Provide Construction Services for Replacement of
Graceland Park/O'Donnell Heights Elementary/Middle School #240 and
Holabird Elementary/Middle School #229
Baltimore City Public Schools (City Schools)

ADDENDUM #6

**GRACELAND PARK/O'DONNELL HEIGHTS ELEMENTARY/MIDDLE SCHOOL NO. 240
BALTIMORE, MARYLAND
ADDENDUM #6**

**HOLABIRD ELEMENTARY/MIDDLE SCHOOL NO. 229
BALTIMORE, MARYLAND
ADDENDUM #6**

DATE	ADD 6
09/25/17	SK-A-6.1

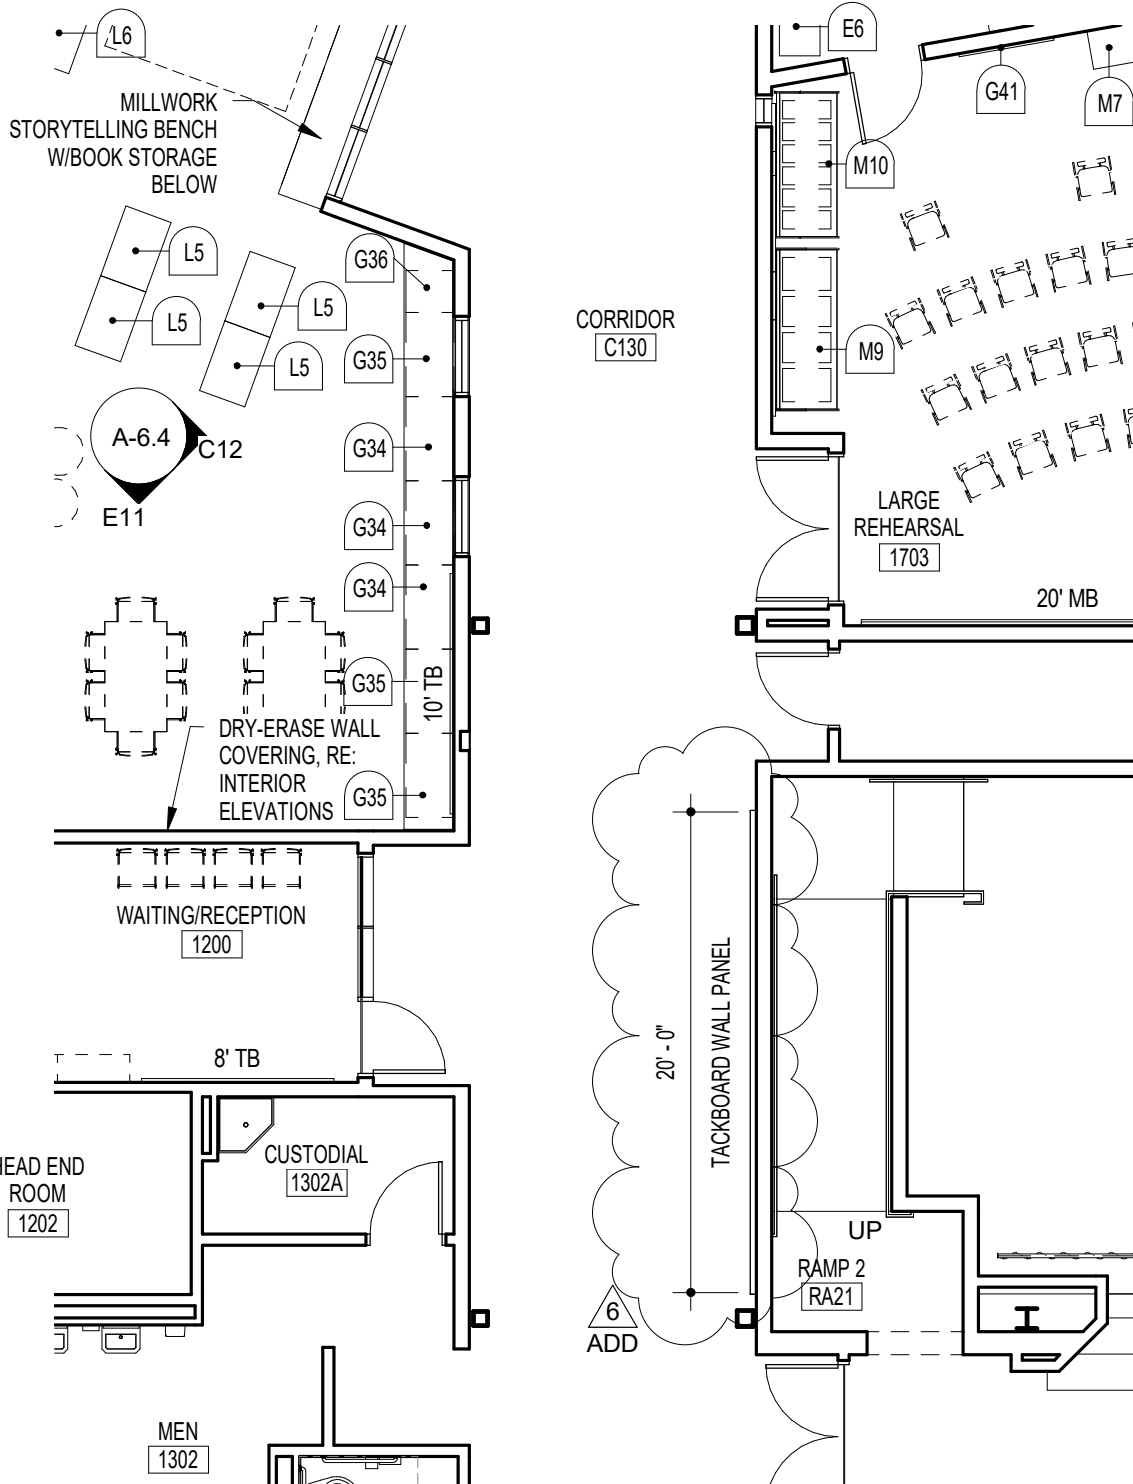
ITEM NO. A1 **SHEET A-9.1**
REVISE Tackboard Wall Panel annotation in Corridor C130 per Sketch SK-A-6.1

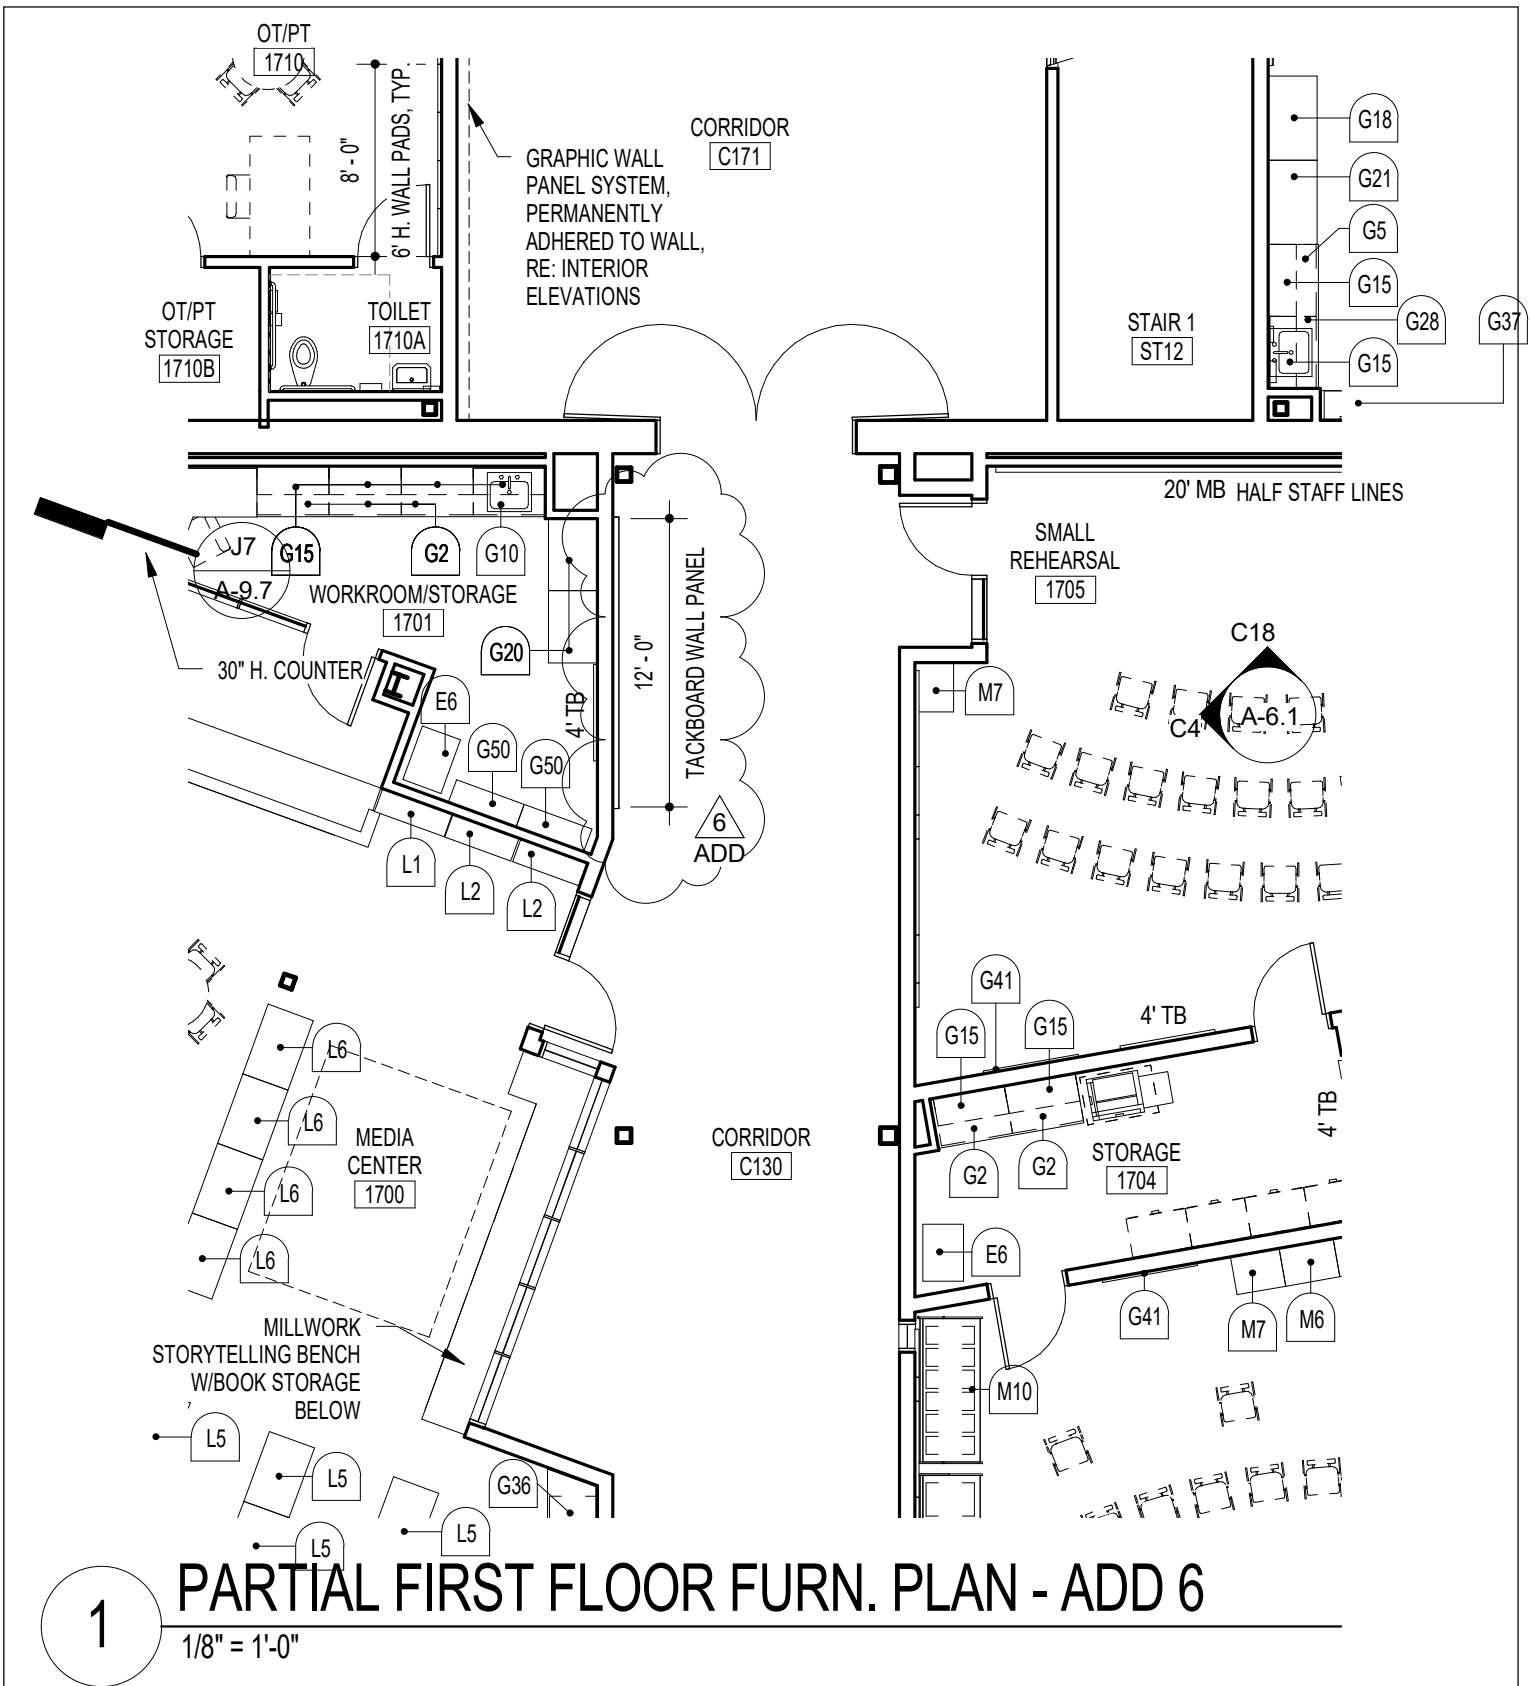
ITEM NO. A2 **SHEET A-9.2**
REVISE Tackboard Wall Panel annotation in Corridor C130 per Sketch SK-A-6.2
REVISE Tackboard Wall Panel annotation in Corridor C180 per Sketch SK-A-6.3

SK-A-6.3

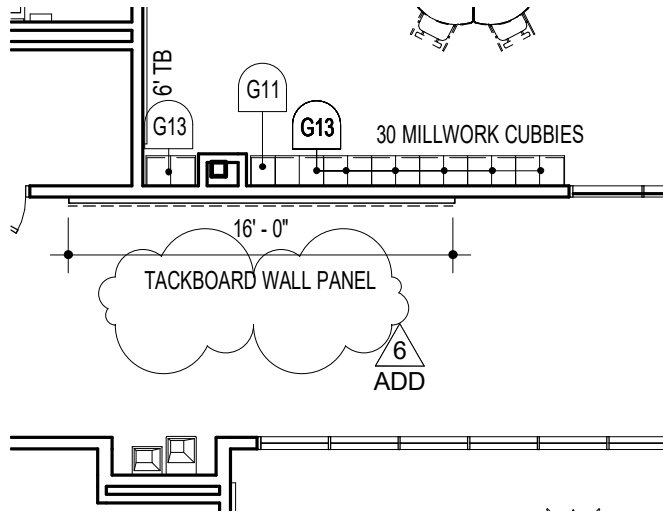
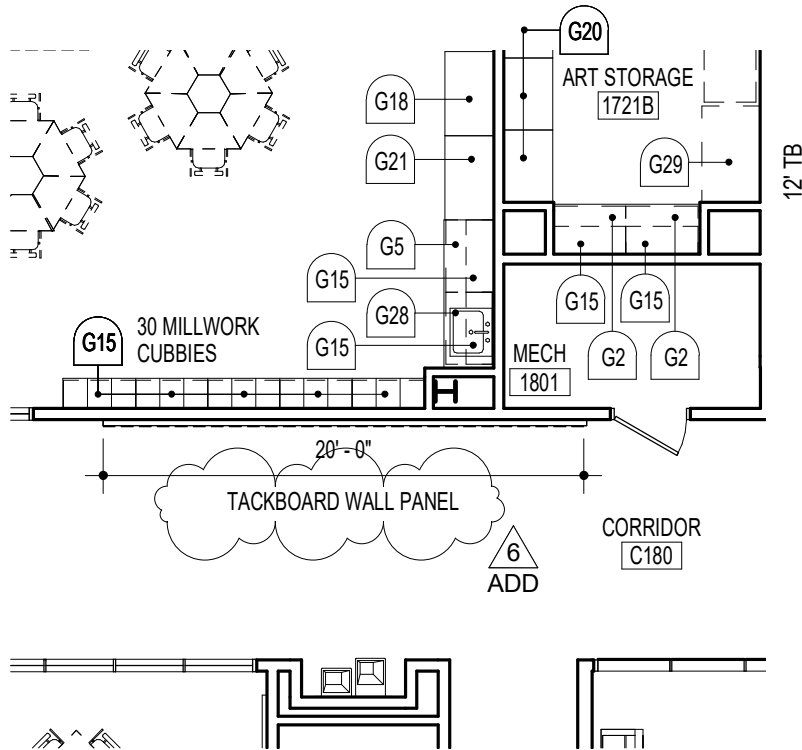
ITEM NO. A3 **SHEET A-9.3**
REVISE Tackboard Wall Panel annotation in Corridor C190 per Sketch SK-A-6.3

SK-A-6.4

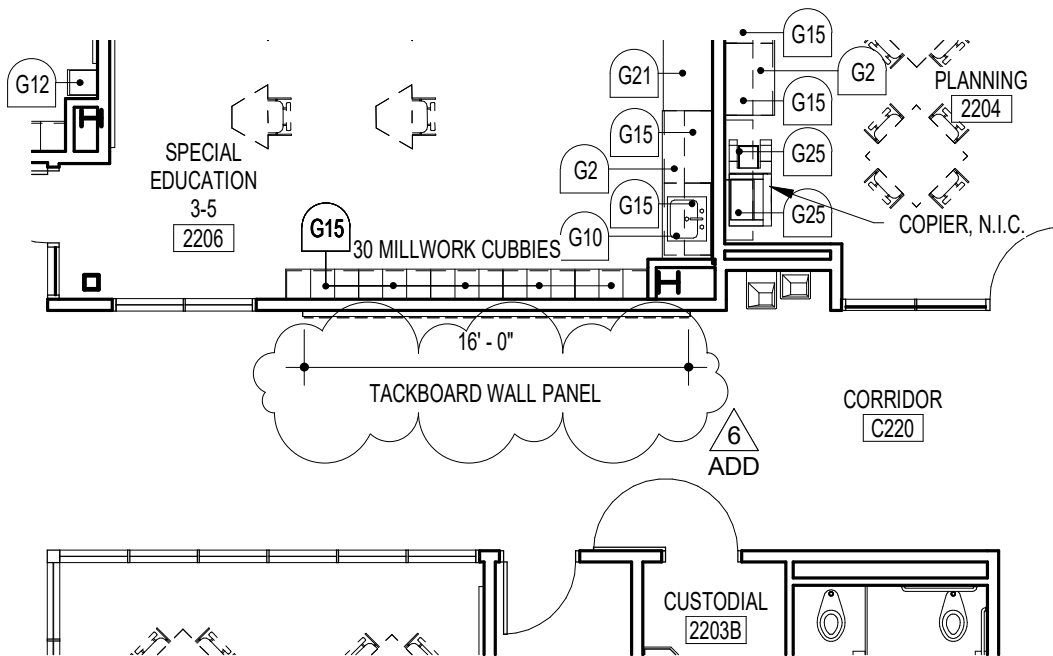
ITEM NO. A4 **SHEET A-9.4**
REVISE Tackboard Wall Panel annotation in Corridor C220 per Sketch SK-A-6.4

SK-A-6.5

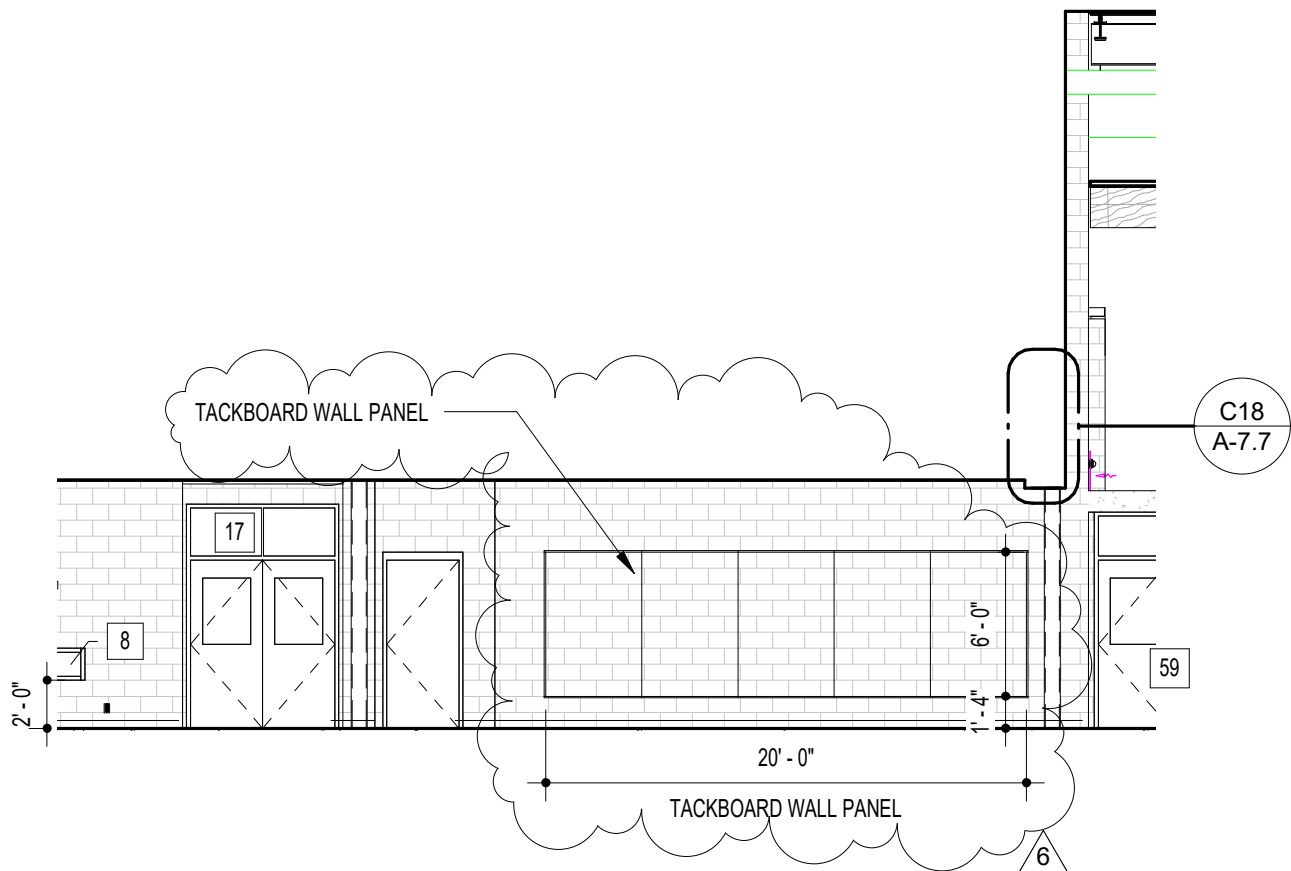
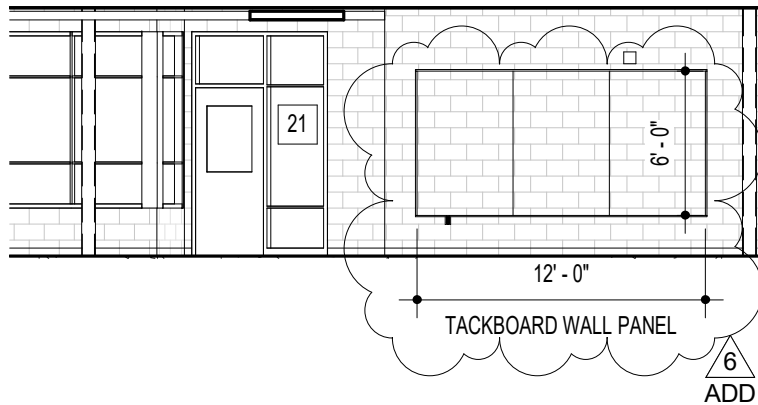
Please advise/give details for the “millwork art display wall” found on elevation D18/A-6.3, and the “millwork wall displays” found on plans at Corridors C130, C180, C190, and C220.

ITEM NO. A5 **SHEET A-6.3**
REVISE Tackboard Wall Panel annotation in Corridor C130 per Sketch SK-A-6.5
REVISE Tackboard Wall Panel annotation in Corridor C180, 190, and 220 per Sketch SK-A-6.6

These 5 items have been renamed in the plan and interior elevation drawings to “Tackboard Wall Panel”. Provide PINnacle N.C.F.R. tackboard by Homosote. Refer to specifications and drawings added in this Addendum.

DATE	ADD 6
09/25/17	SK-A-6.1

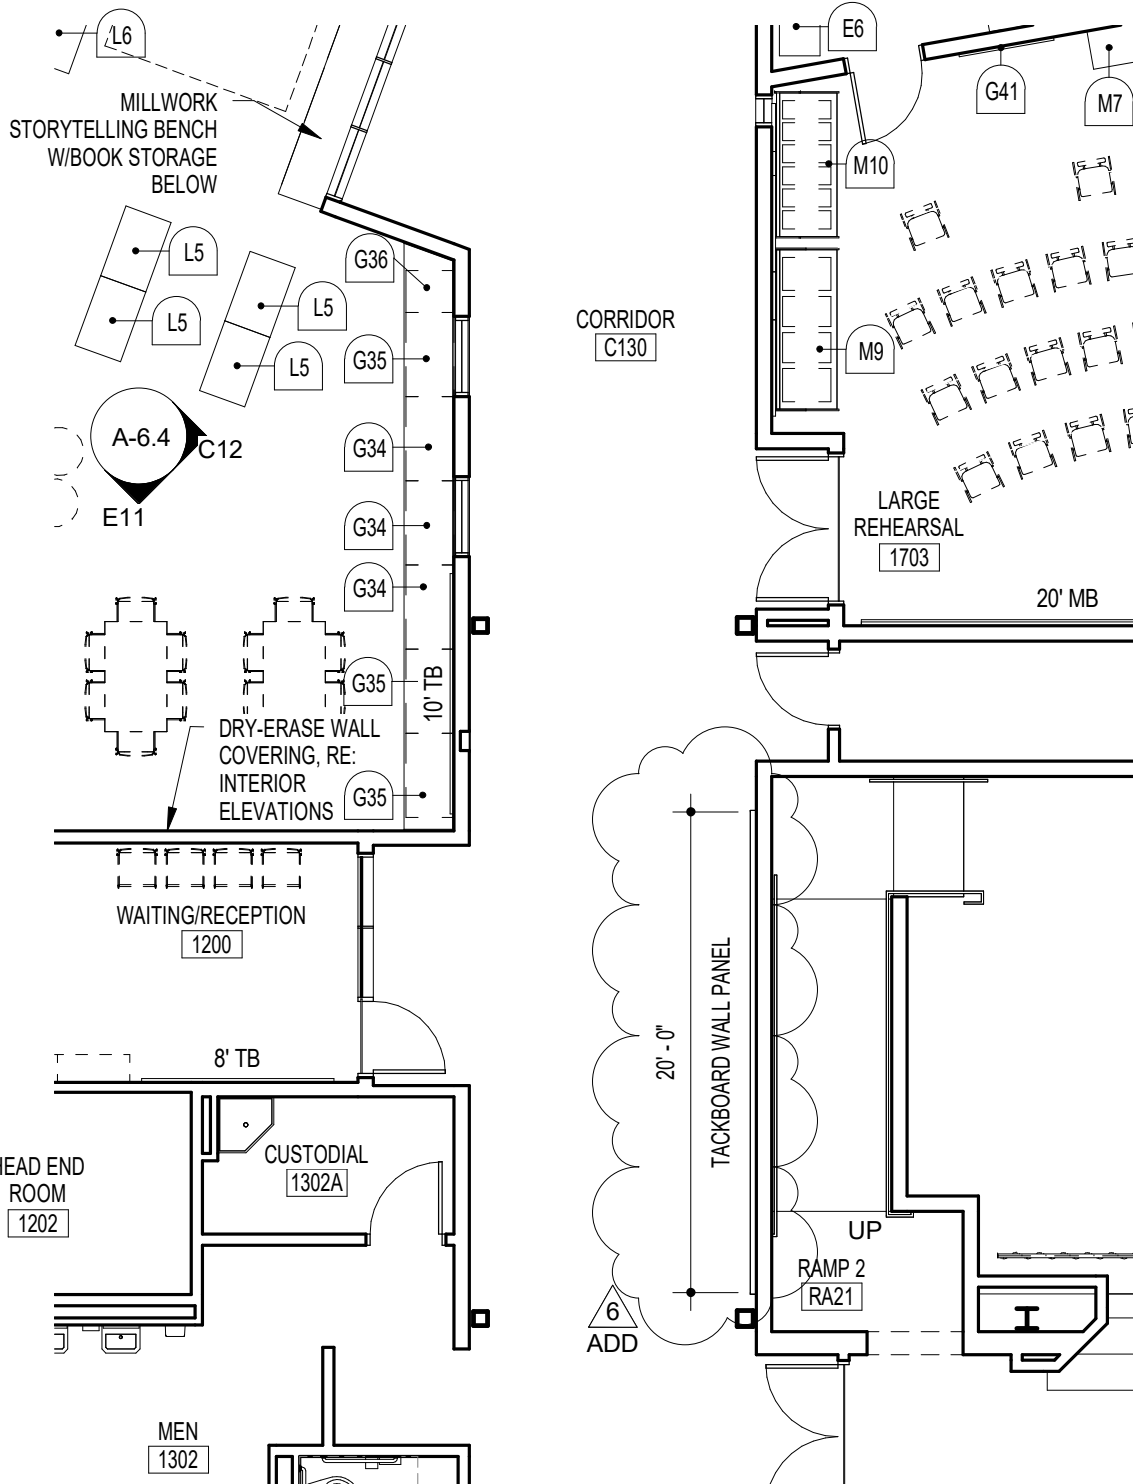
REVISE | <u>SHEET A-9.1</u>
Tackboard Wall Panel annotation in Corridor C130 per Sketch SK-A-6.1 |
